INITIAL FIRE SAFETY INSPECTION REPORT

Motex Fashion

RSC ID: 24179

Date: 05-September-2021

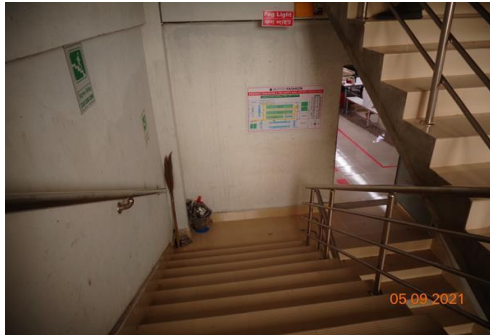
F-9	Means of Egress	Width of exit stairs are found (55inch & 57 inch) which is less than 1.5 m (60 in.).	Provide exit stair minimum clear and unobstructed width of 1.5 m (60 in.) in accordance with Accord standard 6.5.6.2.1.	Within 4 months
